Addendum No.1

Maider Road Waterfront ERP Site Remediation

Addendum No. 1 Issued: 03/26/2021

The purpose of this addendum is to respond to questions following the Pre-Bid Walkover on 03/17/2021, as well as to amend certain bid documents.

Figure 4

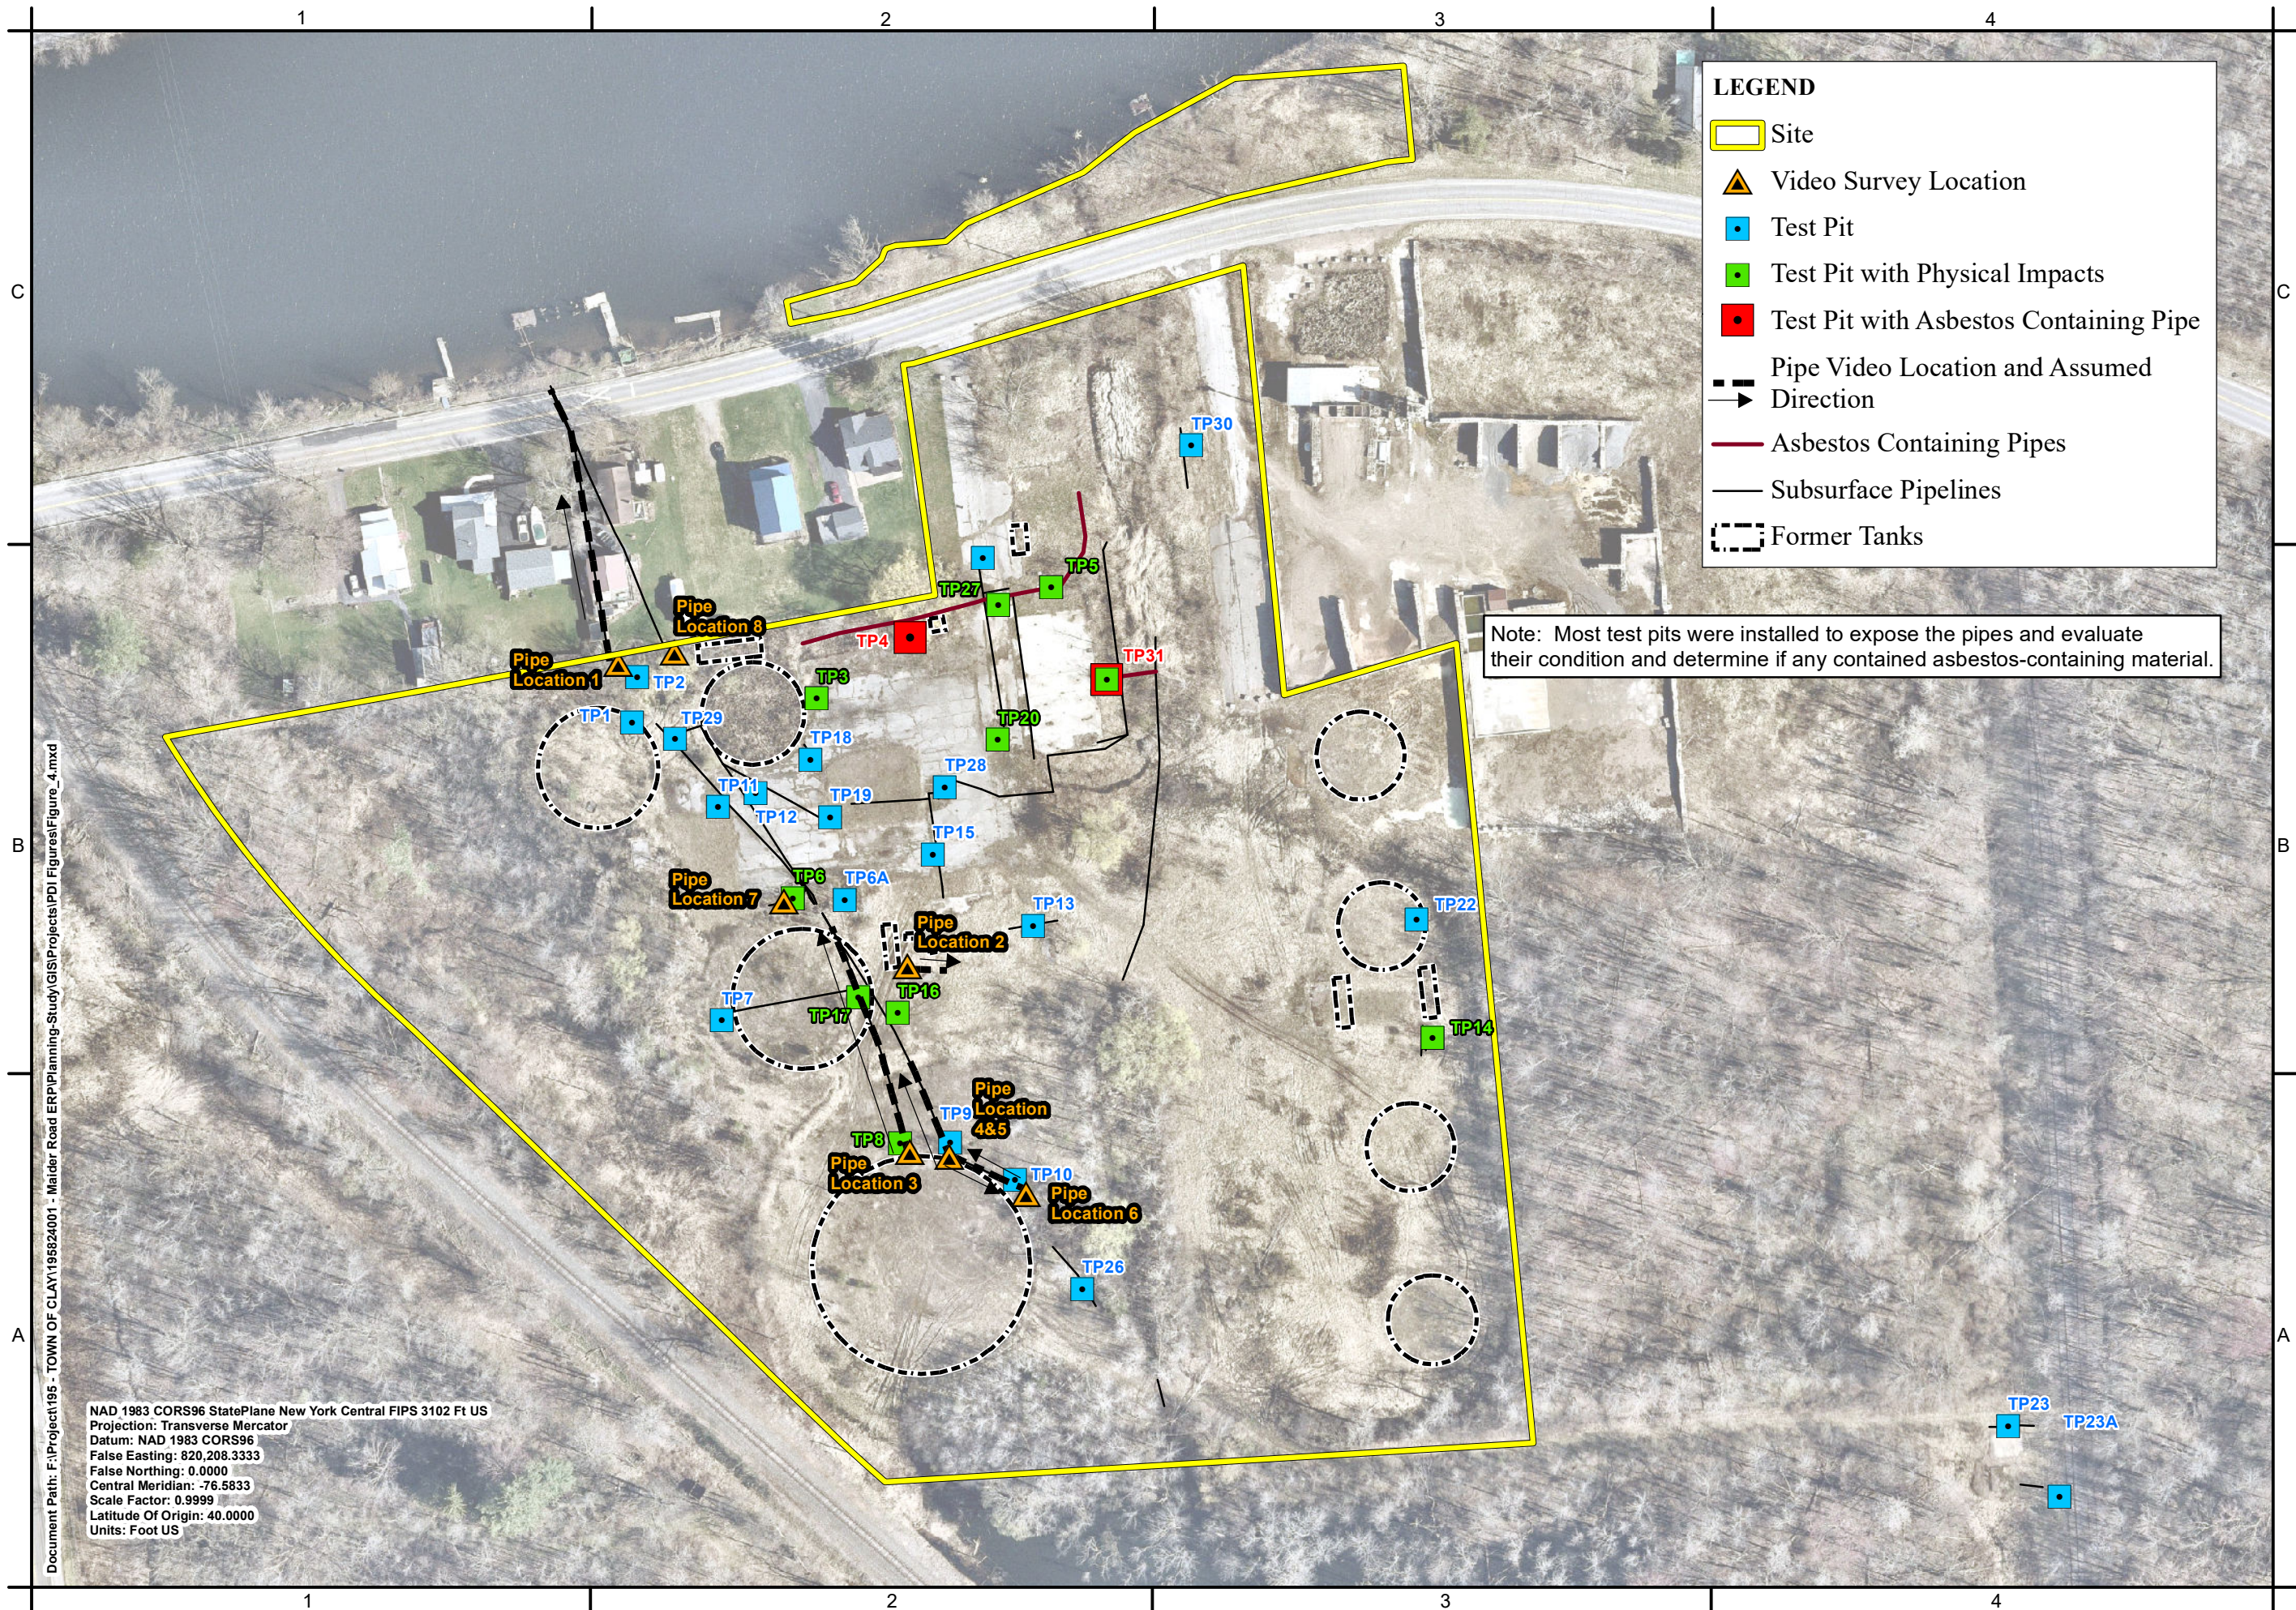
Q: Do you have the approximate depth of the pipe to be removed?

A: The attached tables and figures indicate the size, locations, and depths of the piping.

C-101

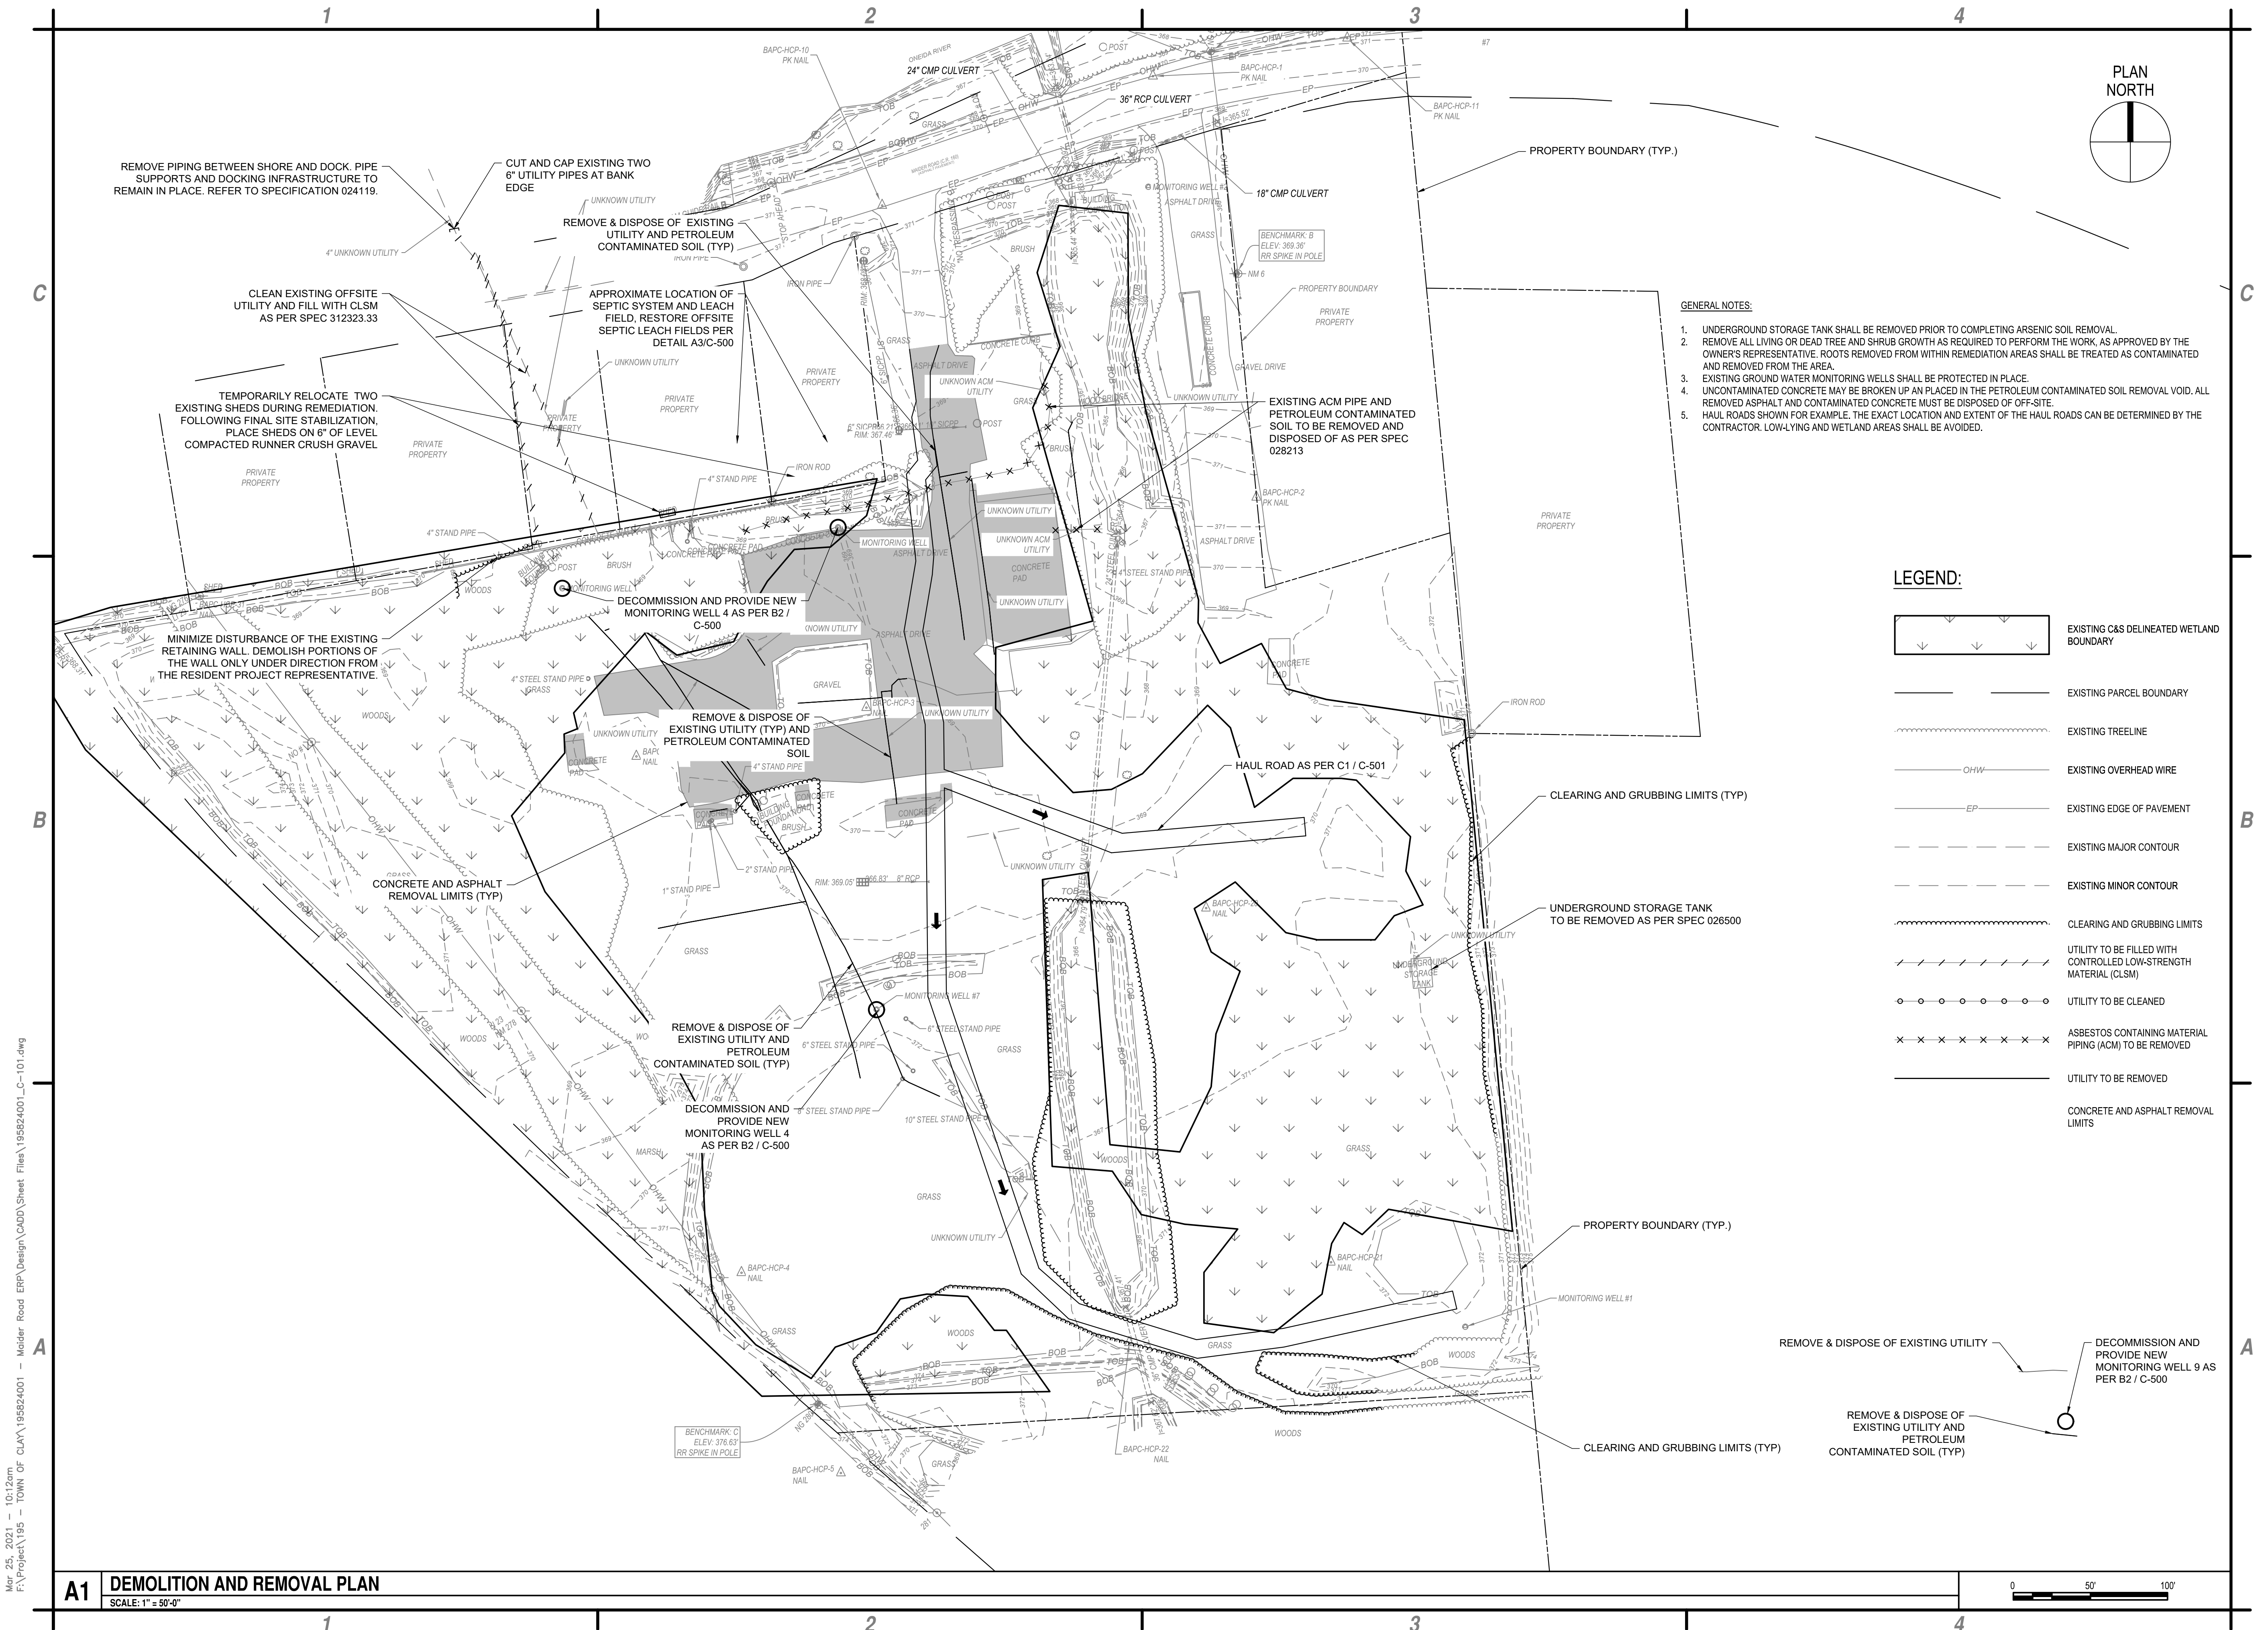
- Drawings:
 - C-101 was modified to reflect the relocation of two residential sheds and updates to work along the river.
 - C-104 was modified to remove the stabilized construction entrance and installation of a turbidity curtain in the river.

WETLAND
IMPACT
PLAN

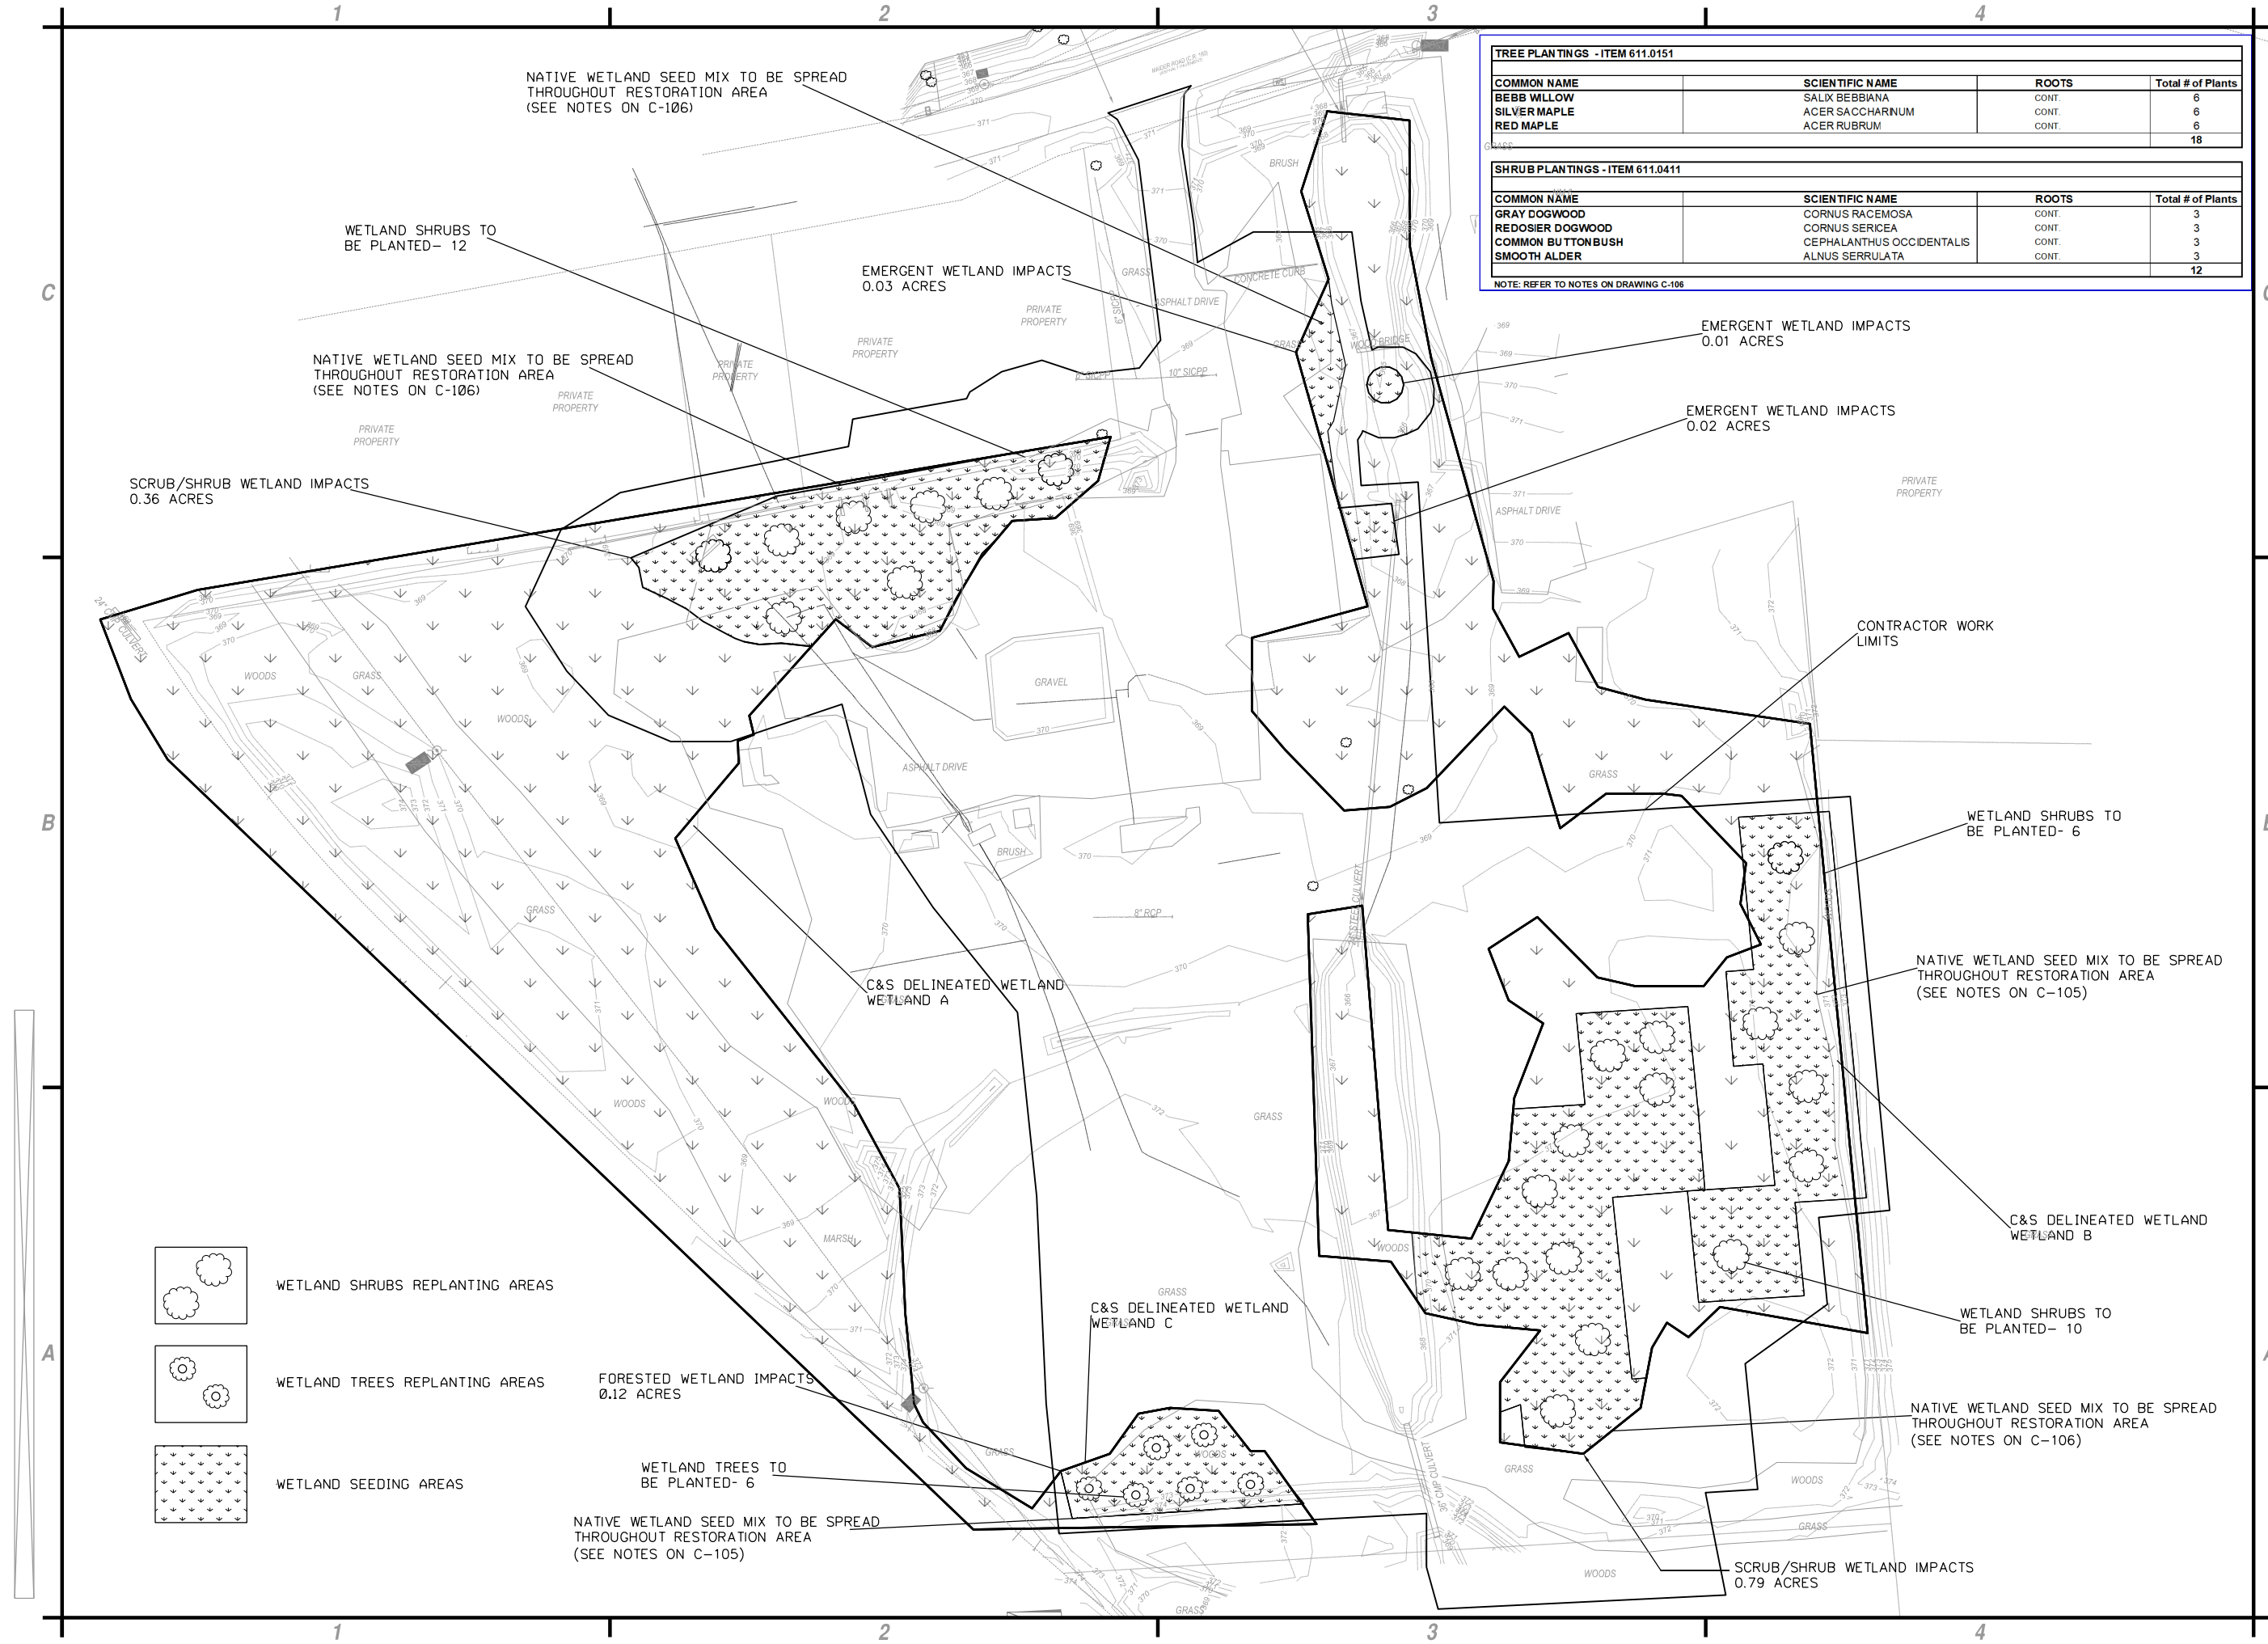
Q: There is a slight discrepancy on wetland areas to be impacted (shown on Drawing C-105) vs areas to be restored (shown on Drawing C-106), 1.43 ac compared to 1.33 ac, respectively. The square yardage listed on the Bid Form Item #42 (Wetland Restoration – on-site), also slightly differs at 1.30 acres. Which would be the correct amount?

A: Attached are the up to date Wetland Restoration Plan Sheets. The table on sheet C-104 indicating 1.31 acres is the correct amount of wetland restoration-on-site. The Bid Sheet lists 6,340 square yards, which is 1.31 acres.
